Subject: Hillsborough County, Southeast County Landfill Revised Leachate Management Plan Operation Permit Minor Modification Application FDEP Permit No. 35435-022-S0-01

Response to March 12, 2021 RAI

HILLSBOROUGH COUNTY SOUTHEAST COUNTY LANDFILL **LEACHATE EVAPORATOR INSTALLATION PERMIT DRAWINGS**

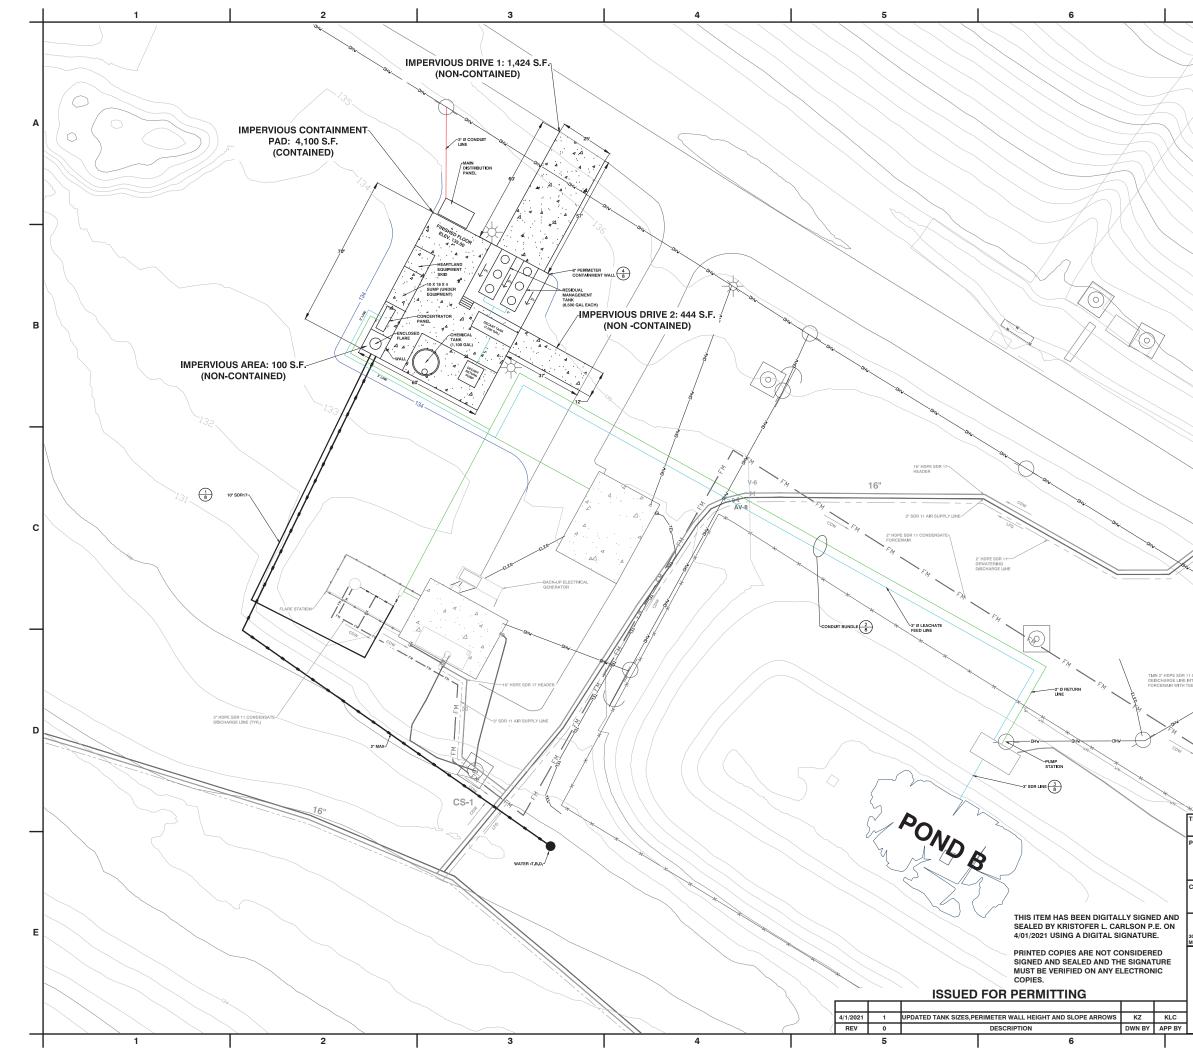
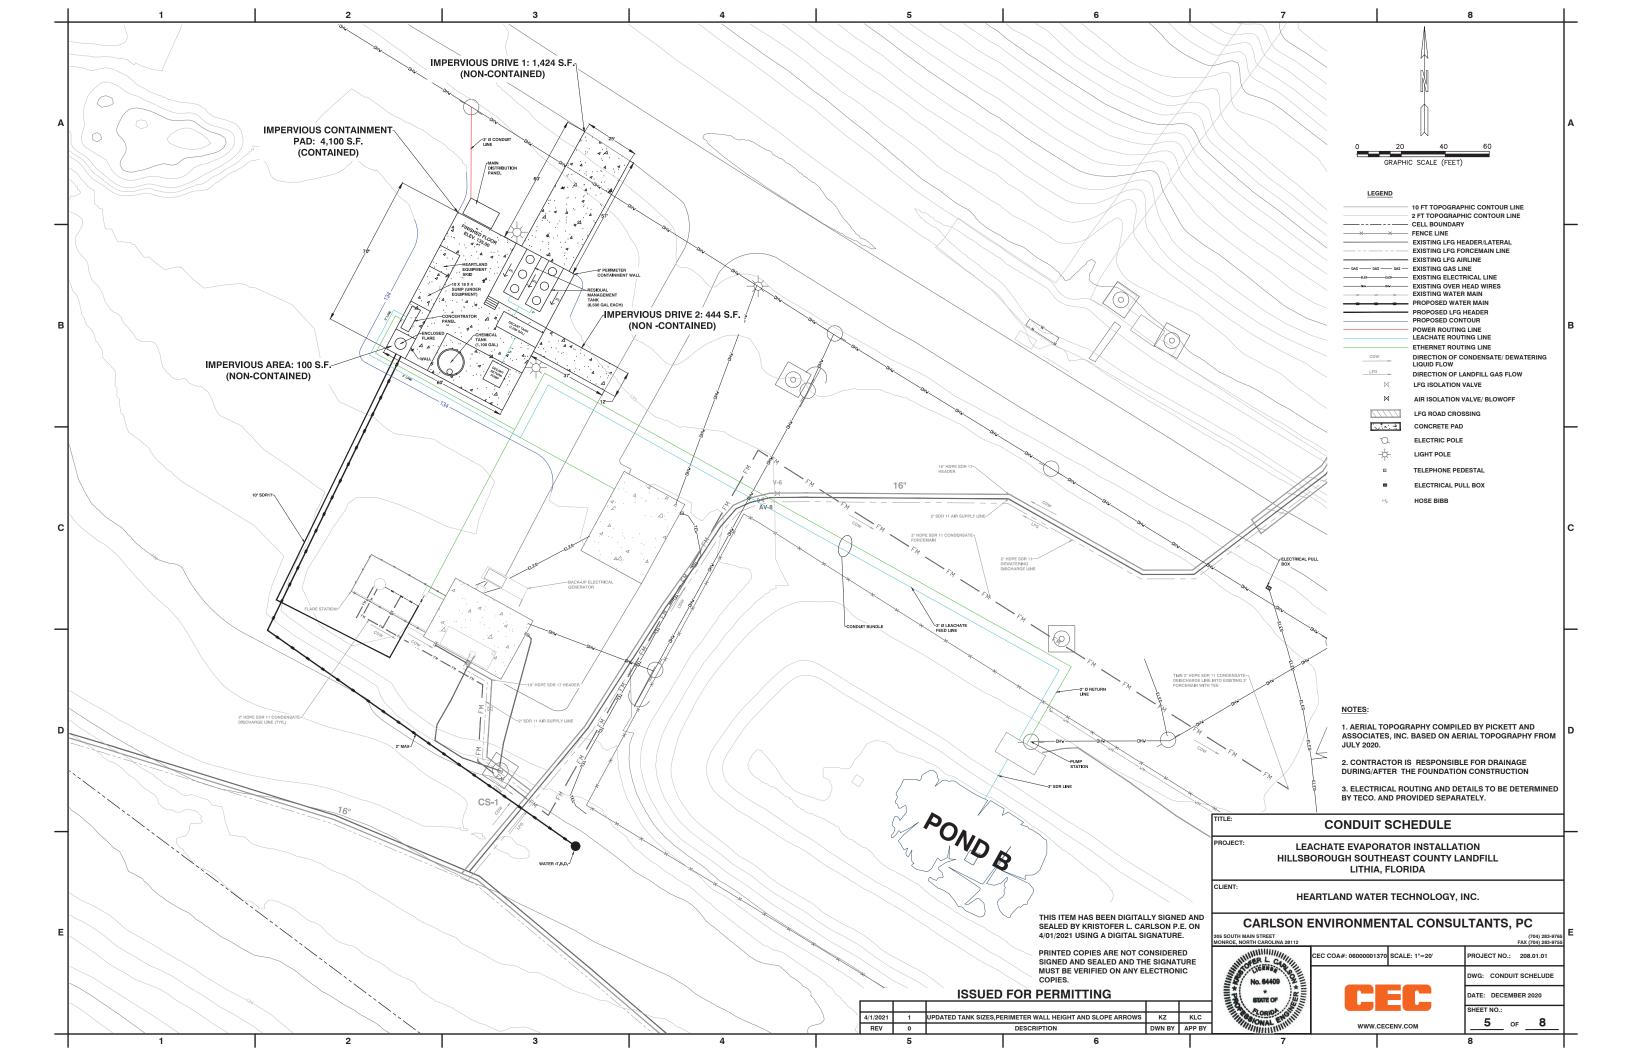
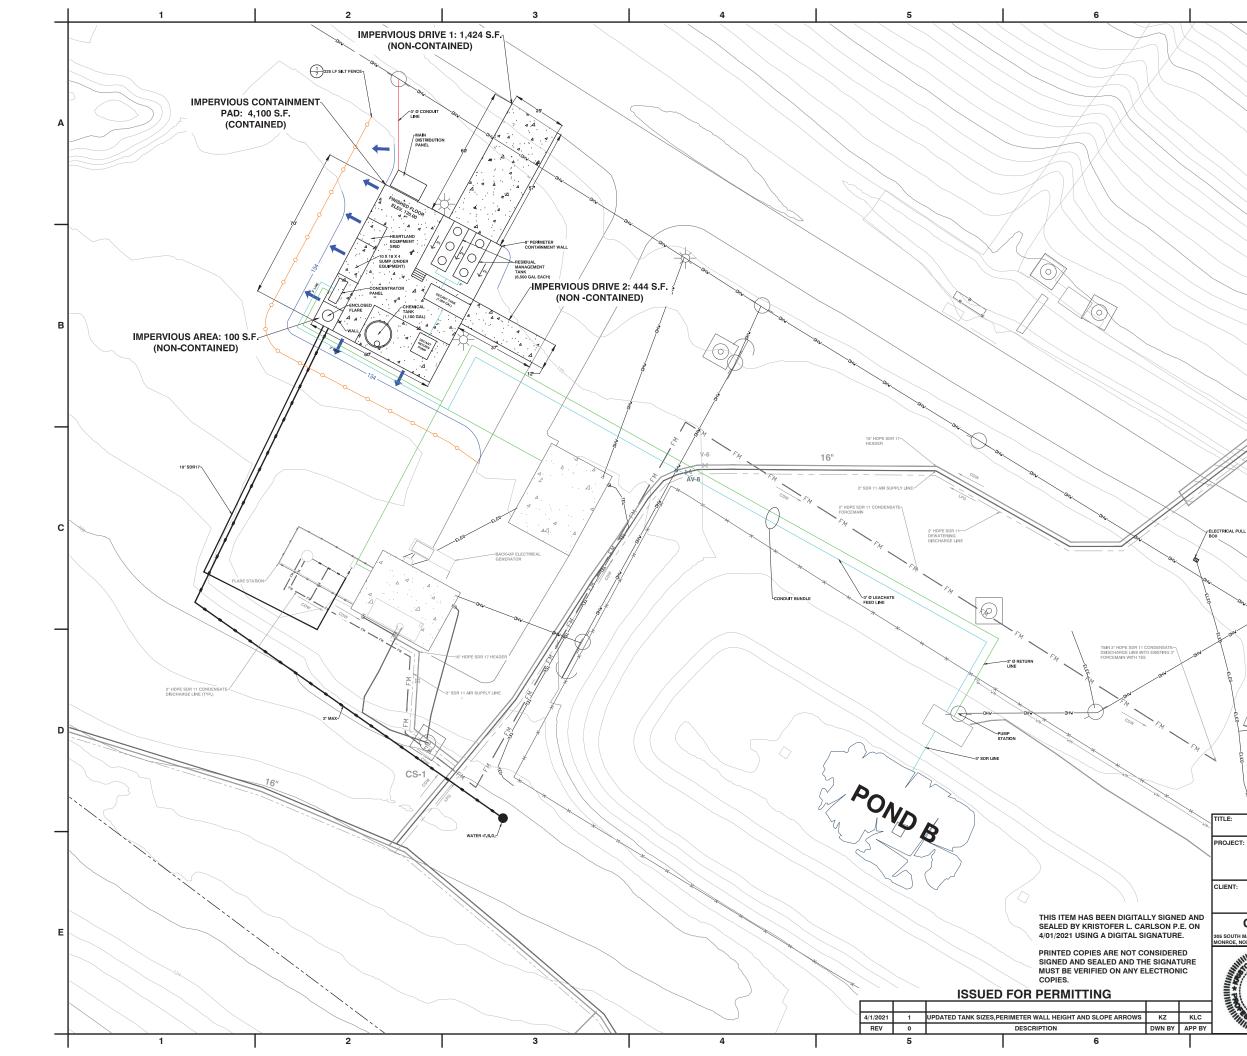
[Electronic Document pages 4, 5, and 6] Sheets 4, 5, and 6. Correct the base drawing used for these sheets. On each sheet the "proposed water main" (thick black line) is drawn connected to a "leachate routing line" (thin cyan line) leaving the Leachate Evaporator Facility (LEF). Regulatory Reference: Paragraph 62-701.320(7)(f)6, F.A.C.

Response: CEC has provided the revised drawings included as a separate file for digital certification purposes. Sheets 4, 5, and 6 incorporate a revised water main alignment and the intended location of the leachate forcemain in accordance with the sheet set legend. The revised drawings have also been resized to 11" X 17" sheets for printability and included as **Attachment 2**.

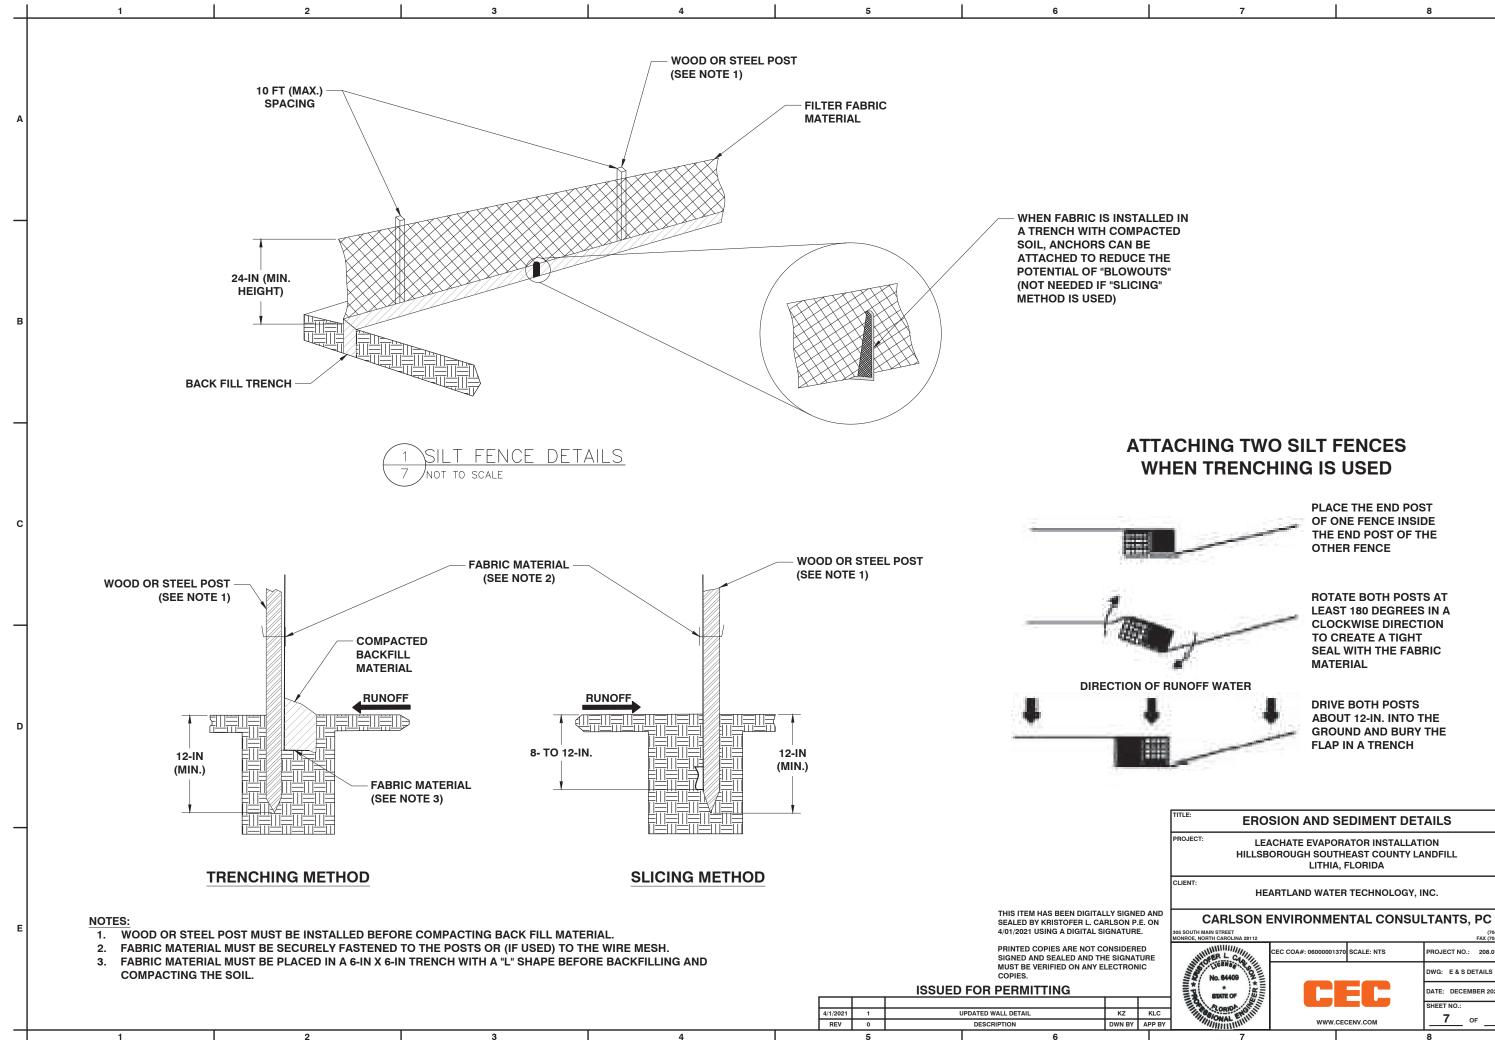
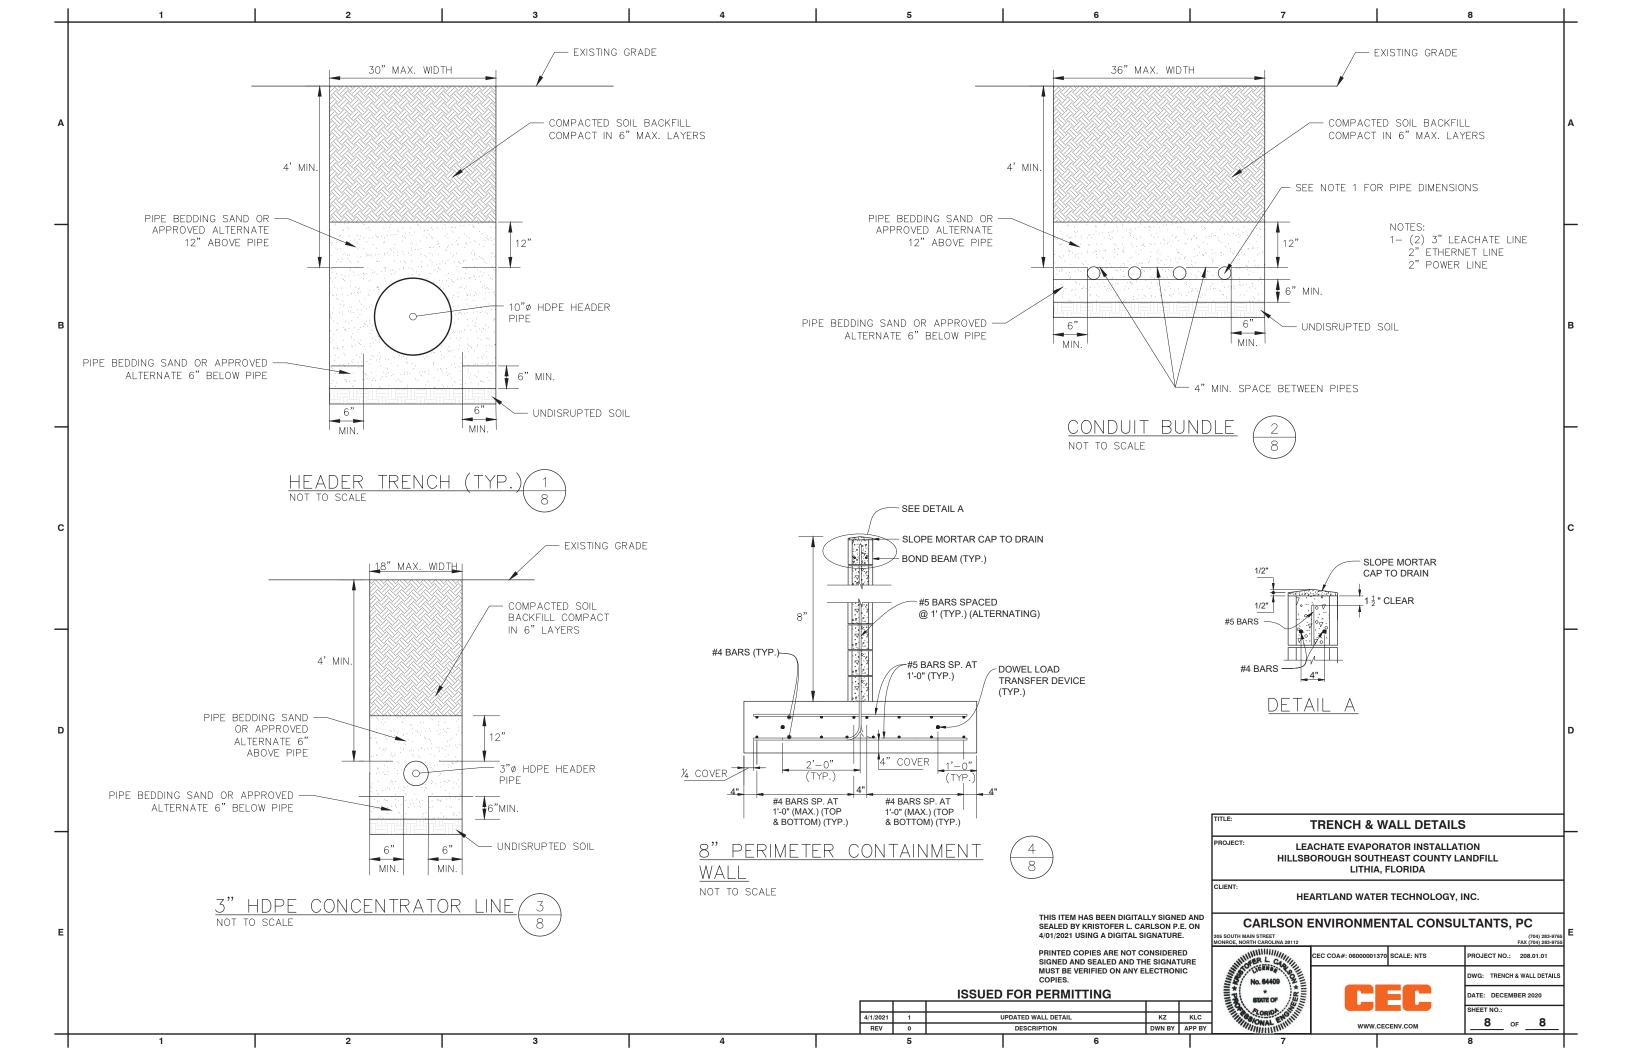
> [Electronic Document page 8] Sheet 8, Detail 2. The leachate originates from the double-lined disposal cell and is conveyed to the LEF. The LEF will be constructed with a containment wall to provide secondary containment of the stored and processed leachate and chemical storage tanks. Evaluate the need to include double-walled piping for the two leachate lines in order to prevent a potential release to the environment. Regulatory Reference: Paragraph 62-701.320(7)(f)6, F.A.C.

[Electronic Document page 8] Sheet 8, Detail 4. In order to determine the required secondary containment volume, specify the height of the "Perimeter Containment Wall." Regulatory Reference: Paragraph 62-701.400(6)(c)5, F.A.C.

Response: The LEF design team, CEC and Heartland Water Technologies (Heartland), have evaluated regulatory requirements and environmental protection considerations in development of the LEF and associated utilities design. The forcemain design includes single-walled standard dimension ratio 11 (SDR 11) high density polyethylene (HDPE) pipe, which is consistent with FDEP regulatory requirements as well as existing forcemain previously installed and currently utilized at the SCLF and other solid waste facilities throughout Florida and the FDEP Southwest District.

Response: CEC has provided the revised drawings included as a separate file for digital certification purposes. Sheet 8, Detail 4 depicts the height of the containment wall as 8" from top of pad to top of containment wall. Secondary containment volume calculations have been completed by CEC and provided as **Attachment 3**. These calculations indicate that each of the containment areas can hold at least 110 percent of the volume of either the largest tank within the containment system or the total volume of all interconnected tanks, whichever is greater in accordance with 62-701.400(6)(c)5, F.A.C. The revised drawings have also been resized to 11" X 17" sheets for printability and included as **Attachment 2**.

Residuals Management Tanks and Decant Tank Flow Diagram (prepared and provided by others)

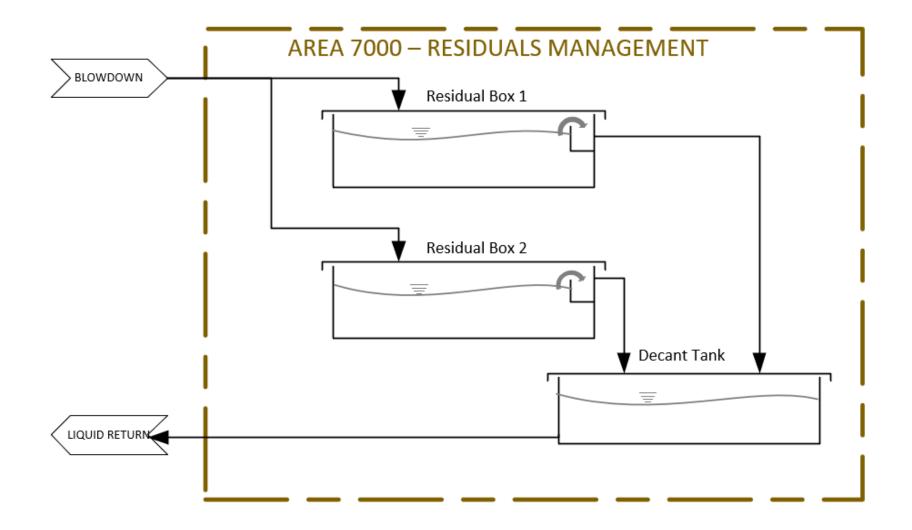
A depicting the Residuals Management Tanks and the Decant Tank flow direction has been included as **Attachment 4**. As described in LMP Section 11.3, and shown in **Attachment 4**, only a single Residuals Management Tank is connected to the Decant Tank at a time. Because the Residuals Management Tank outlets are confined to skimmers in the headspace of the Residuals Management Tanks, they are not considered to be hydraulically connected to the Decant Tank. A catastrophic failure of any of the tankage, such as a tank puncture, would not result in the release of another tank's contents.

Hillsborough County – Southeast Landfill Heartland Brine Concentrator Project - Block Flow Diagram Rev. 1

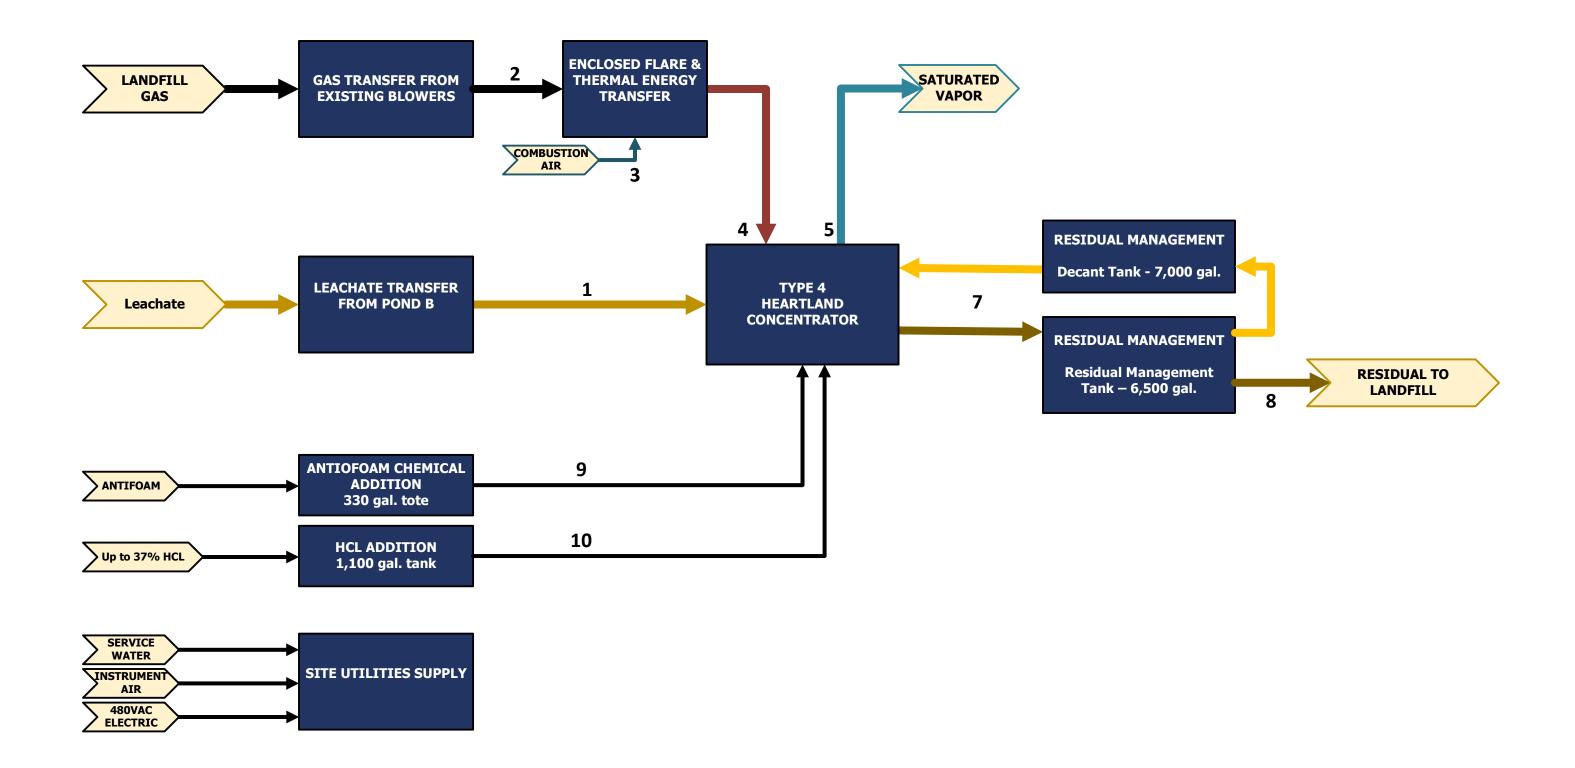
4. [Electronic Document pages 94 and 117] Section 8.4, Leachate Evaporator Facility Volume Reduction, page 23. Details on the three chemical additions shown in Appendix B – Leachate Evaporator Facility Process Flow Diagram are missing from this section. Specify the materials being used and the nature of their use in the LEF (sic). Specify the size of the chemical tank, decant tank, and residual management tank seen on sheets 4, 5, and 6 of the drawings.

In addition, Heartland has provided a revised block flow diagram with supplemental information regarding the chemicals used at the facility which is included as **Attachment 5**. Heartland no longer anticipates that antiscaling chemicals will be required for LEF operation, and the chemical addition has been removed from the updated block flow diagram. The remaining two chemical additions, antifoam and the clean in place (CIP) chemicals are discussed in further detail within Section 8.4 of the LMP. The LMP has also been revised to include an additional Section 11.3 which includes information regarding proposed LEF tankage, secondary containment, and spill countermeasures. A revised LMP with revisions identified in redline and strikeout is included as **Attachment 6**. A conformed and digitally certified LMP with changes incorporated is included with this transmittal as a separate attachment.
